Item ID: D350-689-023

Item Name: Floor Provisions - Energy Attenuating Seat Compatible

DART SERVICE INSTRUCTION

TO AMEND INSTALLATION INSTRUCTIONS IIN-D350-689 REV. B AND INSTRUCTIONS FOR CONTINUED AIRWORTHINESS ICA-D350-689 REV. 1

FIGURE 1: UPDATES TO CROSS SECTIONS F-F AND M-M

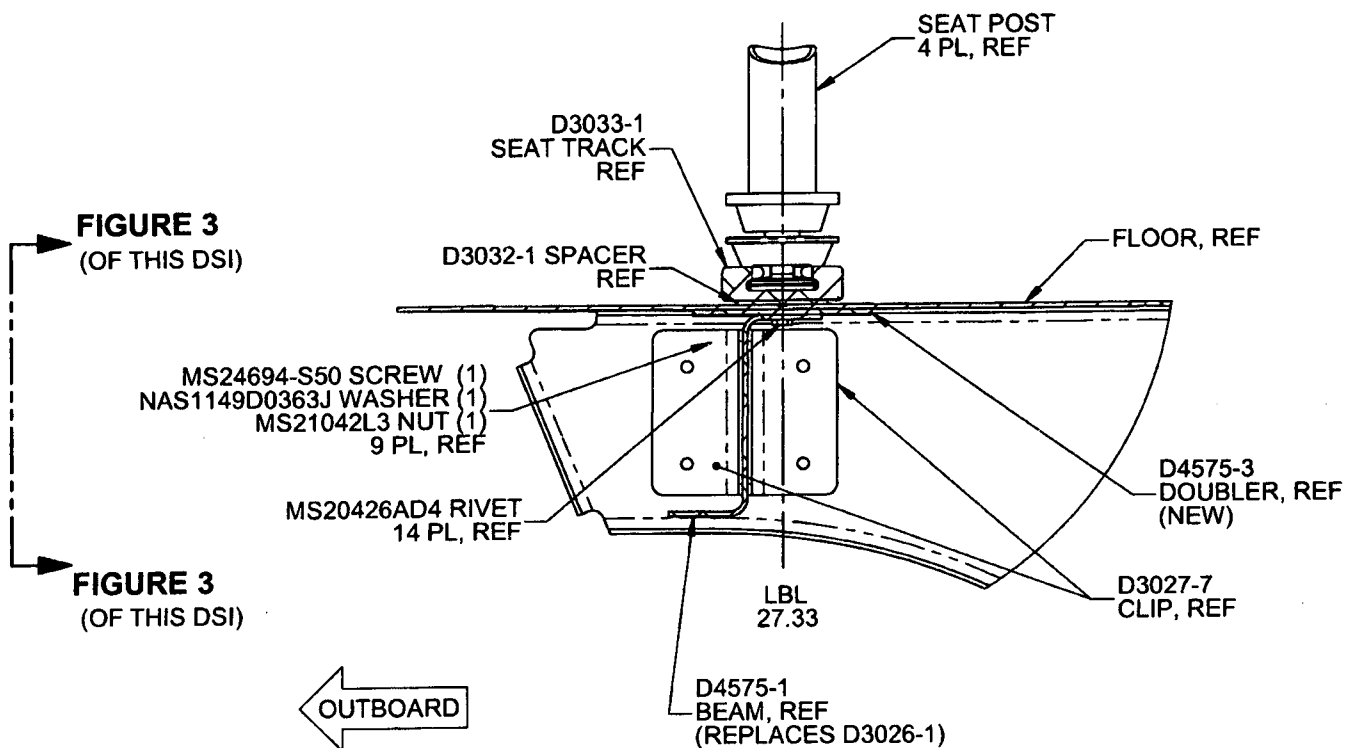
If there is an existing stringer at LBL 27.33, it will need to be removed from that location. Locate D4575-1 Beam, D4575-3 Doubler, and D3032-1 Spacer as shown in Figure 1 of this Service Instruction. Transfer drill existing holes from the aircraft floor to the D4575-1 Beam, D4575-3 Doubler, and D3032-1 Spacer. Ensure 1.0" to 1.5" rivet pitch and add additional holes if required. If there is no existing stringer, locate D4575-1 Beam, D4575-3 Doubler, and D3032-1 Spacer as shown in Figure 1 of this Service Instruction and drill Ø0.128" holes on a 1.0" to 1.5" pitch.

Counter sink holes in the D3032-1 Spacer for MS20426AD4 rivets. Install D4575-1 Beam, D4575-3 Doubler, and D3032-1 Spacer to floor using MS20426AD4 rivets.

Rivet D3234-1 Doubler to D3025-1 Beam as shown in Figure 7 using MS20470AD4 rivets. Continue at step 3.3.25.

FIGURE 2: UPDATES TO FIGURE 21 (IIN-D350-689) AND 25-21 (ICA-D350-689)

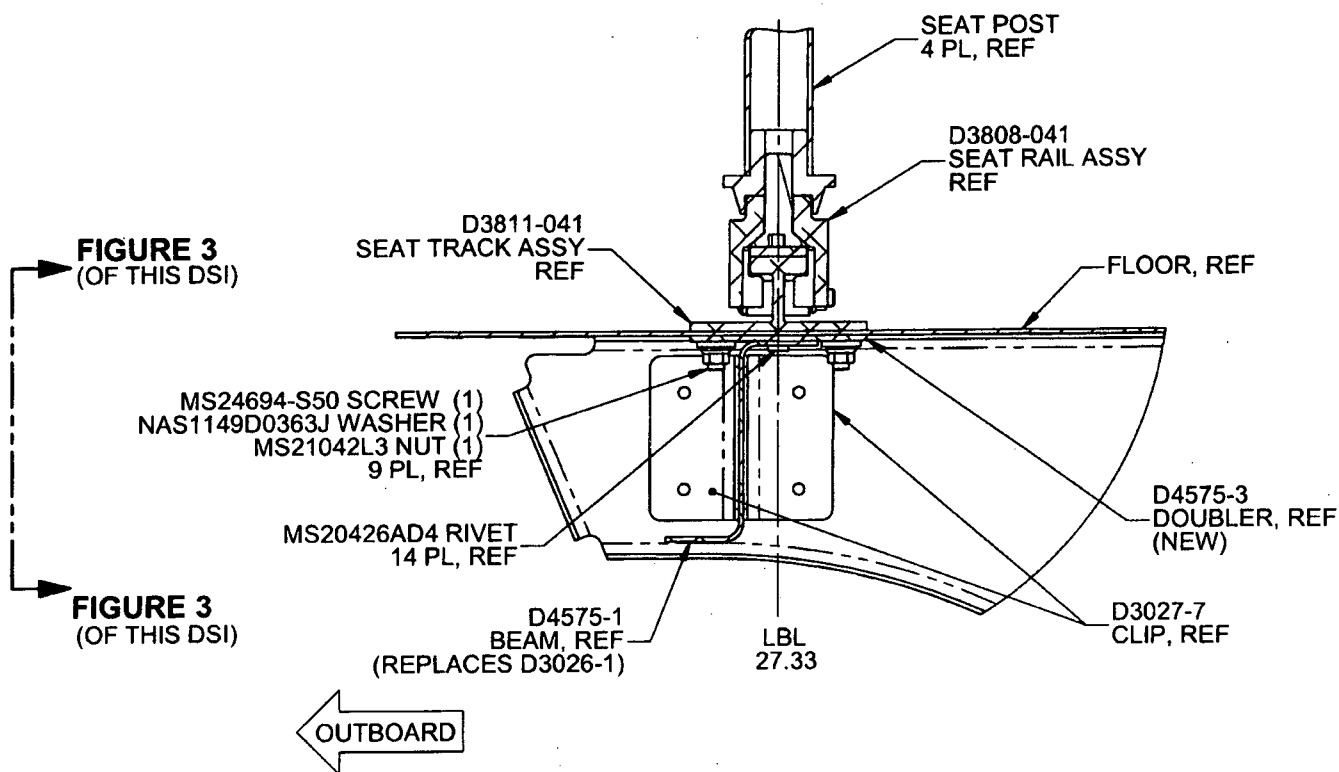
If there is an existing stringer at LBL 27.33, it will need to be removed from that location. Locate D4575-1 Beam and D4575-3 Doubler as shown in Figure 2 of this Service Instruction. Transfer drill existing holes from the aircraft floor to the D4575-1 Beam and D4575-3 Doubler. Ensure 1.0" to 1.5" rivet pitch and add additional holes if required. If there is no existing stringer, locate D4575-1 Beam and D4575-3 Doubler as shown in Figure 1 of this Service Instruction and drill Ø0.128" holes on a 1.0" to 1.5" pitch.

Attach D4575-1 Beam and D4575-3 Doubler to floor using qty (14) MS20426AD4 rivets.

FIGURE 3: RELIEFS ON D4575-1/-3
(ONLY D4575-1/-3 SHOWN FOR CLARITY)
VIEW LOOKING INBOARD

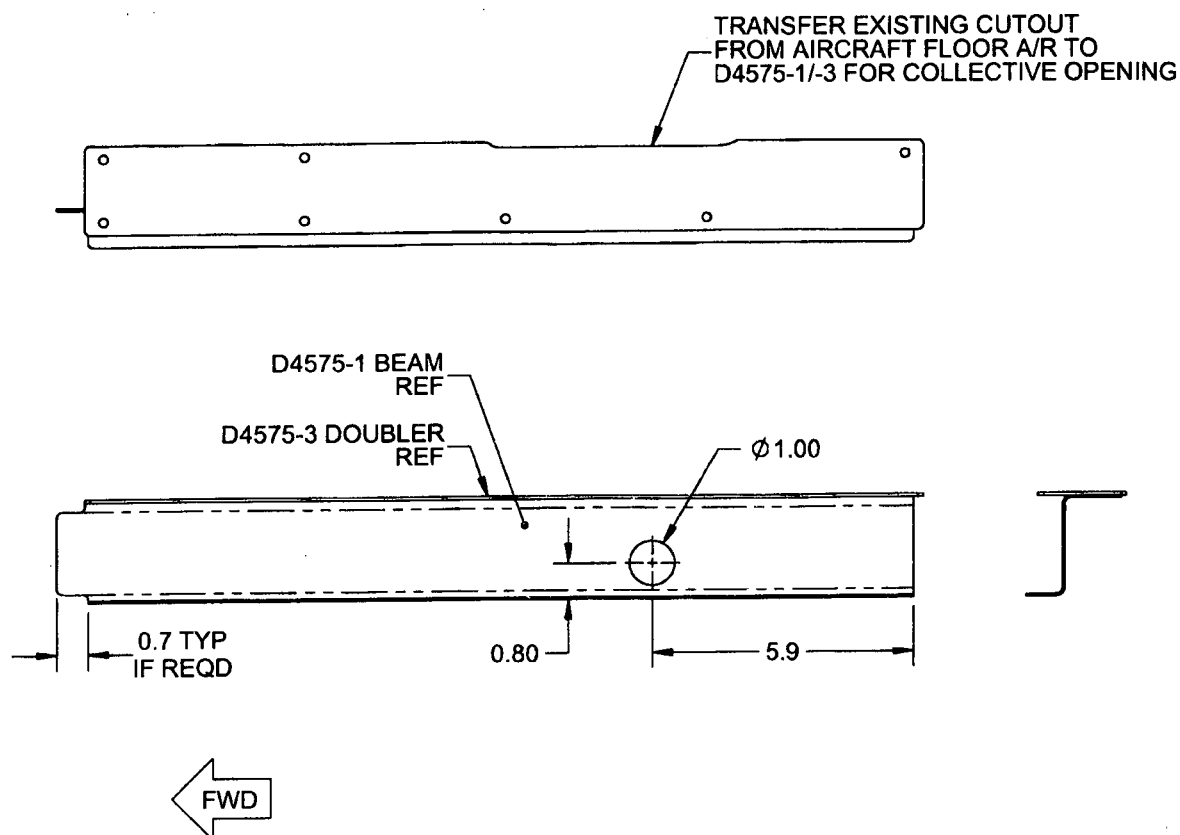
Note: Drill a Ø1.00" (Ø25.4 mm) hole in the D4575-1 Beam to clear extension tube of collective and cutout as required for clearance of collective opening and fwd bulkhead as shown in Figure 3 of this Service Instruction.

Note: Drill a Ø1.00" (Ø25.4 mm) hole in the D4575-1 Beam to clear extension tube of collective and cutout as required for clearance of collective opening and fwd bulkhead as shown in Figure 3 of this Service Instruction.
